Access Compliance Report

Public Rights-of-Way

(Pedestrian Signals)

Intersection ID: N/A	Main Street:	Cross Street: N/A	Location: N/A
ADA ID: 9DE1219B37E8	Signal Type: Two Push Buttons-Non APS	Overall Compliance: No	Severity Score: BTN 1:N/A BTN 2: N/A No BTN: N/A
Codes/Mitigation Info/Possible Solution		Field Measurements/Component Compliance

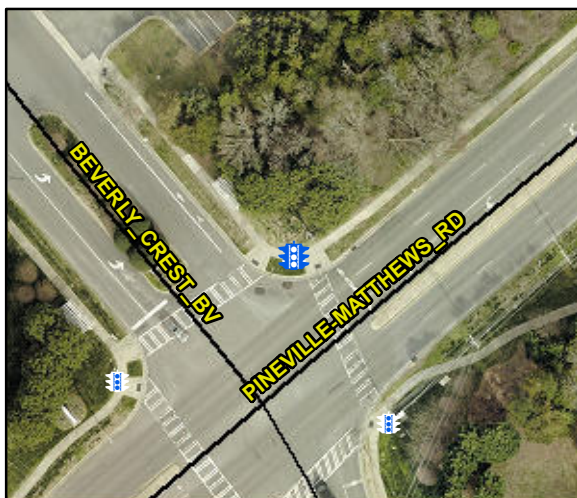
N/A	B 1 FWD Approach Obstruction?	Yes	N/A	B 2 FWD Approach Obstruction?	Yes
N/A	B 1 FWD Approach Obstruction Dist (in)	4.0	N/A	B 2 FWD Approach ObstructionDist (in)	4.0
N/A	B 1 PARA Approach?	Yes	N/A	B 2 PARA Approach?	Yes
N/A	B 1 PARA Approach Constrained?	No	N/A	B 2 PARA Approach Constrained?	No
No	B 1 PARA Approach Reach (in)	12.0	No	B 2 PARA Approach Reach (in)	24.0
N/A	B 1 PARA Approach Width (in)	N/A	N/A	B 2 PARA Approach Width (in)	N/A
N/A	B 1 PARA Approach Obstruction?	No	N/A	B 2 PARA Approach Obstruction?	Yes
N/A	B 1 PARA Approach Obstruction Dist (in)	4.0	N/A	B 2 PARA Approach ObstructionDist (in)	4.0
N/A	B 1 Clear Floor Space Slope (%)	N/A	N/A	B 2 Clear Floor Space Slope (%)	N/A
N/A	B 1 Clear Floor Space XSlope (%)	N/A	N/A	B 2 Clear Floor Space XSlope (%)	N/A
N/A	B 1 PAR Slope (%)	11.8	N/A	B 2 PAR Slope (%)	7.0
Yes	B 1 Height (in)	39.0	Yes	B 2 Height (in)	37.0
Yes	B 1 Pressure (#)	2.5	Yes	B 2 Pressure (#)	2.5

Yes	B 1 Clear Xing Direction?	ClearlyMarked	Yes	B 2 Clear Xing Direction?	ClearlyMarked
	B 1 Crossing Direction	To SE		B 2 Crossing Direction	To SW
Yes	B 1 DistanceTo XWalk (in)	12.0	Yes	B 2 DistanceTo XWalk (in)	24.0
No	B 1 DistanceTo Curb (in)	192.0	No	B 2 DistanceTo Curb (in)	228.0
Yes	B 1 Diameter (in)	2.0	Yes	B 2 Diameter (in)	2.0

Possible Solutions: Replace Signal Push Button With APS Button on New Post. Remove & Relocate Sign.
